APPLICATION FOR PERMIT TO DRILL, DEEPEN, OR PLUG BACK

2. NAME OF OPERATOR  
 Tenneco Oil Company

8. FARM OR LEASE NAME  
 Butler Canyon Unit USA

9. WELL NO.  
 33-12

PAD LAYOUT

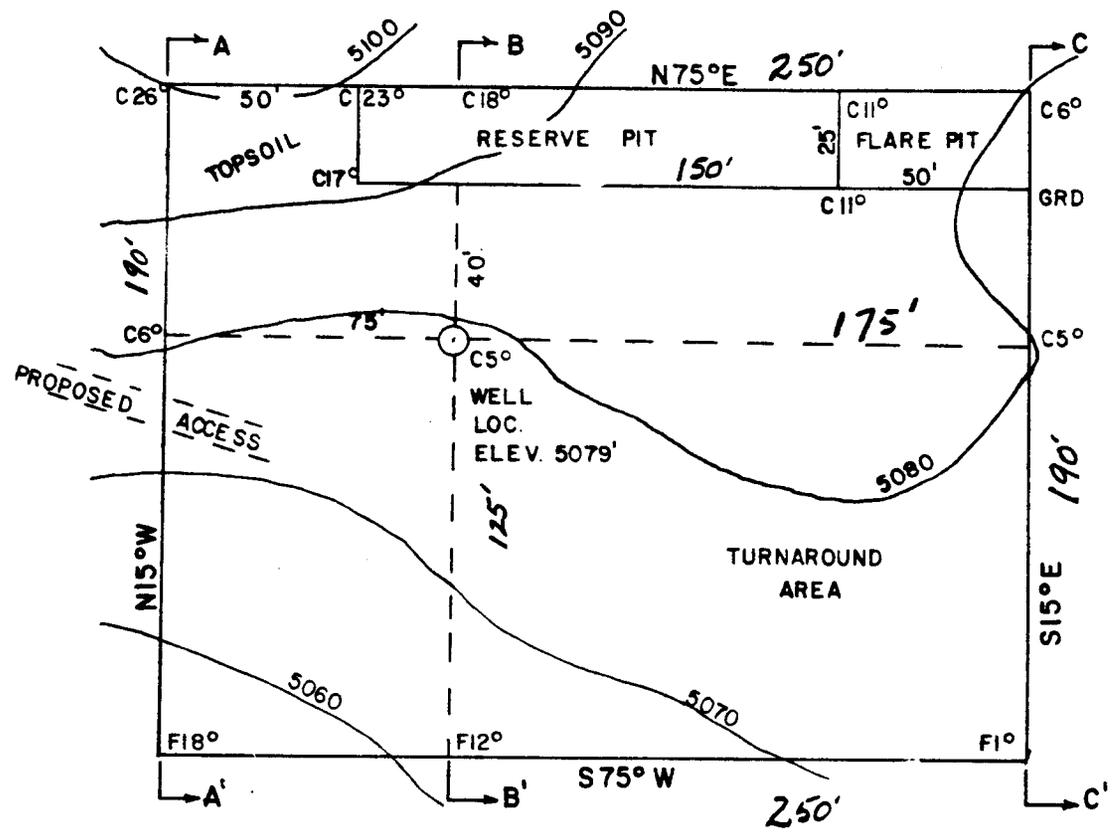
- 1) Pit(s) will be in the cut portion of the pad, fenced with 5 strands barbed wire on three sides prior to drilling and on the 4th side prior to rig removal.
- 2) Restoration plans will be in accordance with Part 10 of your Surface Use Plan.

- 3) Pad site will be no larger than 190 feet wide x 250 feet long, as shown on exhibit 3. No surface area will be disturbed beyond this footage.
